HISTORIC AND DESIGN REVIEW COMMISSION

HDRC CASE NO: 2021-249
ADDRESS: 110 E RISCHÉ
LEGAL DESCRIPTION: NCB 2556 BLK A LOT 8
ZONING: RM-4, H
CITY COUNCIL DIST.: 1
DISTRICT: Nathan Historic District
APPLICANT: James Ochoa /OCHOA ANTONIA G & JAMES P
OWNER: James Ochoa /OCHOA ANTONIA G & JAMES P
TYPE OF WORK: Rear privacy fence
APPLICATION RECEIVED: May 12, 2021
60-DAY REVIEW: Not applicable due to City Council Emergency Orders
CASE MANAGER: Huy Pham
REQUEST:

The applicant is requesting a Certificate of Appropriateness for approval to replace the existing 5-foot chain link fences with new 8-foot wood privacy fencing in the rear yard on the south and west property lines, including a steel security door on the west side.

PLOT (SITE) PLAN
(SAMPLE ONLY)

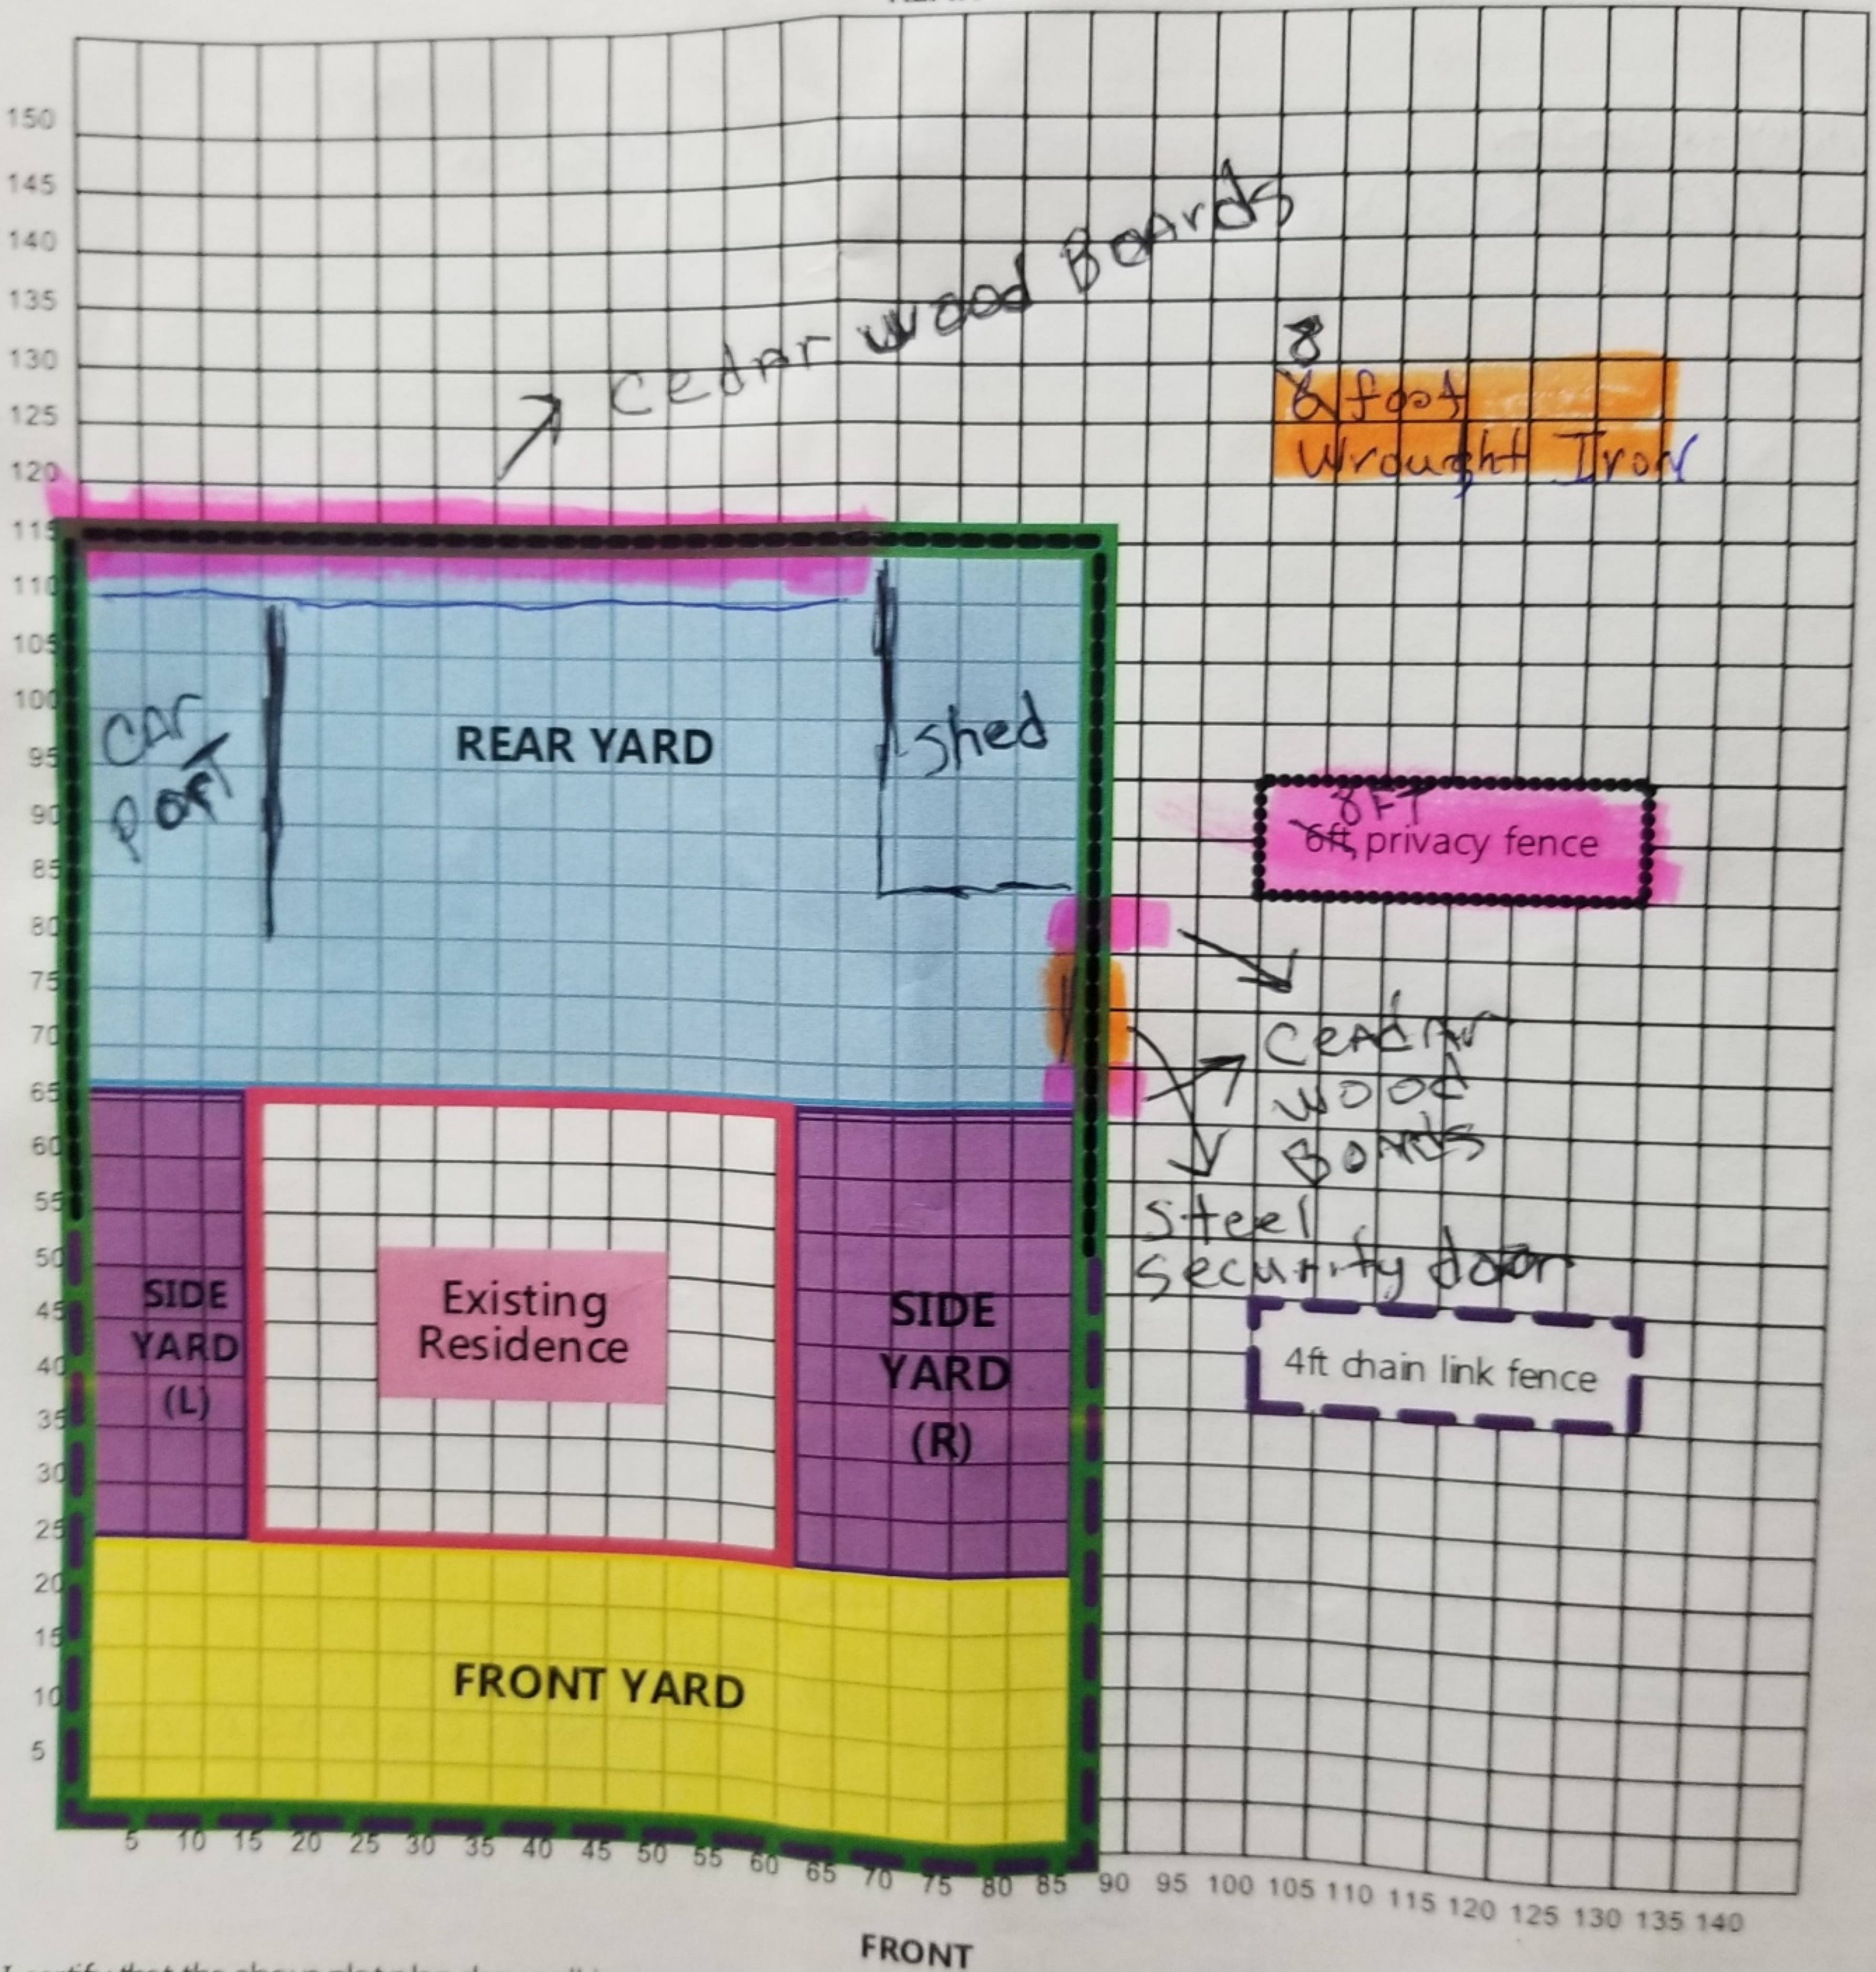
- c. FENCE DESIGN – The applicant has proposed use of “cedar wood boards” and “steel security door” as annotated on the site plan. However, no example photo or drawing has been submitted at this time. Staff finds that a typical wood privacy fence appropriate and that the door or gate should visually blending into the wood privacy fence material and design; the applicant may coordinate with staff administratively for final approval of the fence and gate design.

Staff recommends approval of the fence design based on finding c with the stipulation the privacy fence feature a typical wood plank design and that door or gate should visually blending into the wood privacy fence material and design rather than a steel security door; the applicant may coordinate with staff administratively for final approval of the fence and gate design.
